Subject: MHI's Responses to US-APWR DCD RAI No. 459-3331

**Responses to Request for Additional Information No. 459-3331,
Revision 1**

RAI NO.: NO. 459-3331 REVISION 1
SRP SECTION: 03.06.02 – Determination of Rupture Locations and Dynamic Effects Associated with the Postulated Rupture of Piping
APPLICATION SECTION: 3.6.2
DATE OF RAI ISSUE: 09/16/2009

RAI 03.06.02-9(e)

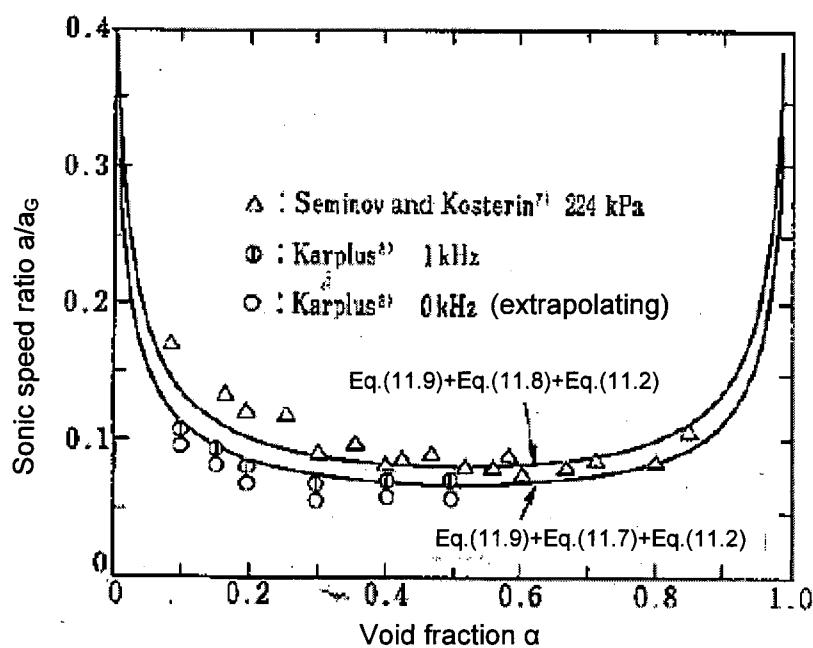
(e) There does not appear to be any consideration of how potential feedback between the jet and any nearby reflecting surface(s), which can increase substantially the dynamic jet forces impinging on the nearby target component and the dynamic thrust blowdown forces on the ruptured pipe through resonance, is considered. Provide details (with example, if available) that describe the methods including a description of how feedback amplification of dynamic blowdown forces will be considered for calculating the blowdown forcing functions at break locations and identify the computer program that will be used, if any.

The sonic speed of air-liquid two phase flow is decreased because the sonic wave is reflected by droplets as shown in the figure below. This decrease of sonic speed varies with droplet density, and the sonic speed itself has a distribution in the jet. Then the resonance phenomena itself does not occur because the frequency of pressure wave propagation changes by location. Therefore, the feedback of dynamic blowdown forces does not occur and amplification of feedback of dynamic blowdown forces does not have to be considered for calculating the blowdown forcing functions at break locations.

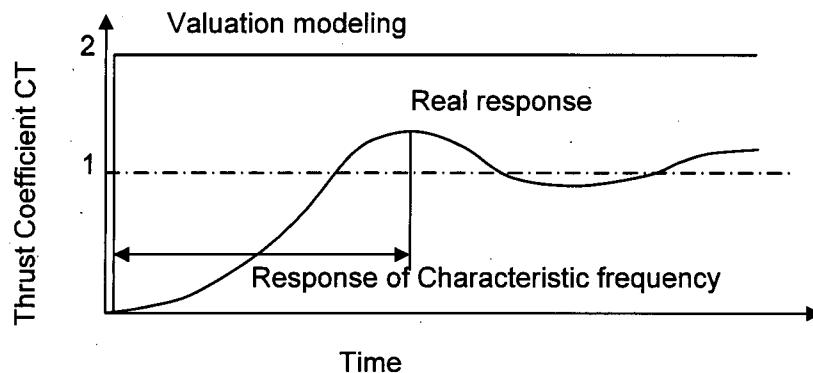
In its response to RAI 03.06.02-10, MHI stated that the loading time duration of a blast wave on a structure neighboring a pipe break would be negligibly small (less than 1/400th of a second), so that the impulse load acting on the structure (computed by integrating the product of the force and application time) would be negligible compared with loads induced by a jet impingement. However, based on the information in the Knowledge Base for Emergency Core Cooling System Recirculation Reliability, February 1996, Issued by the NEA/CSNI, <http://www.nea.fr/html/nsd/docs/1995/csnir1995-11.pdf>, and ACRS concerns [Wallis - ADAMS ML050830344, Ransom - ADAMS ML 050830341], all high pressure and temperature pipes should be considered as sources of blast waves with initial energy and mass roughly equal to the exposed volume from a hypothesized break. The subsequent damage from such waves has been well documented and is not properly accounted for in ANS 58.2 by the isolated analysis of a pure spherically expanding wave. MHI should provide a rigorous and thorough explanation of their procedures for estimating the effects of blast waves on nearby SSCs. Also, the staff points out that blast wave load analyses should be based on three dimensional (or asymmetric) unsteady analysis of the flow field, with appropriate representation of the surrounding structures, subsequent to the initial blast. MHI is requested to document their blast wave assessment approach(es) in a revised version of the DCD.

The propagation of shock wave is affected by the surrounding sonic speed. The sonic speed at the end of the propagating shock wave is one of air, because downstream of the shock wave is air. It is possible that the blast wave force is evaluated using the pressure difference between the shock wave back and forward, and the velocity of the shock wave. Also, the property of shock wave can be evaluated using the pressure ratio of pipe break opening mouth to atmosphere and initial energy of pipe break opening mouth.

This progressive velocity of the shock wave seems to be greater than sonic speed of the air and the passing time duration of shock wave on a structure is extremely short. Even if the Mach number of shock wave is equal to 1.0, the passing time duration of shock wave on a barrier structure having thickness of 1 m (3.28 ft) is about $1/350^{\text{th}}$ of a second. Therefore, as for the barrier structure having natural frequency of less than 50Hz, the passing time duration of shock wave on the barrier structure is a split second.

The force on the barrier structure subjected to blast wave is as shown in the figure below. The response of the barrier structure can not follow the shock wave because the shock wave passes the barrier structure in a split second. The force on the barrier structure subjected to blast wave is less than twice of the static force generated by shock wave. Therefore, the MHI method is conservative even if dynamic response is considered.
